HARTING Product Change Notification

PCN/18/021/C+N

Product range: Interface connectors / PushPull, RJ, ix & har-
port

Title: Improvement of RJ Industrial 10G + PN - External

Modified top and bottom shells

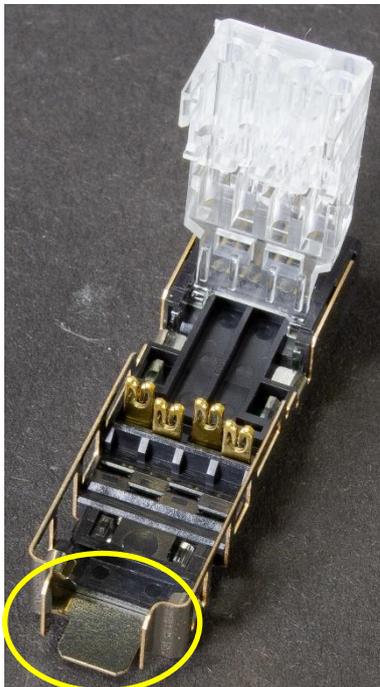
The top and bottom shells for the 8-pole and 4-pole HARTING RJ Industrial® 10G RJ45 IDC connectors are modified in order to improve the shield resistance for Profinet cables with minimum and maximum diameter of the shielding braid.

Reason: *improve the shield resistance for cables with min/max diameter of the shielding braid*

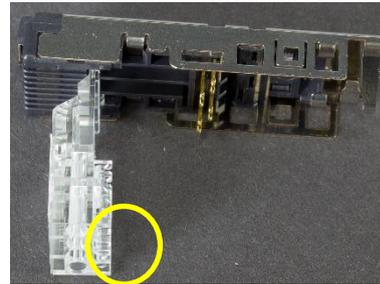
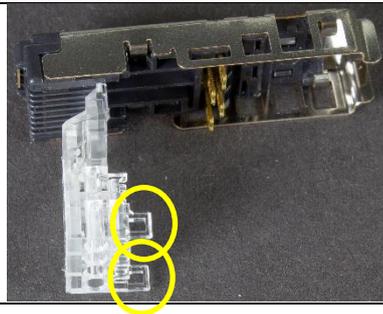
In addition the two hooks of the plastic wire manager are suppressed in order to improve the handling. The hooks are disturbing the installer during the insertion of the upper 4 single wires.

*Change of the shape of the plastic wire manager, suppress the two hooks
Reason: Improve the handling, the two hooks are disturbing during the assembly of the upper 4 single wires.*
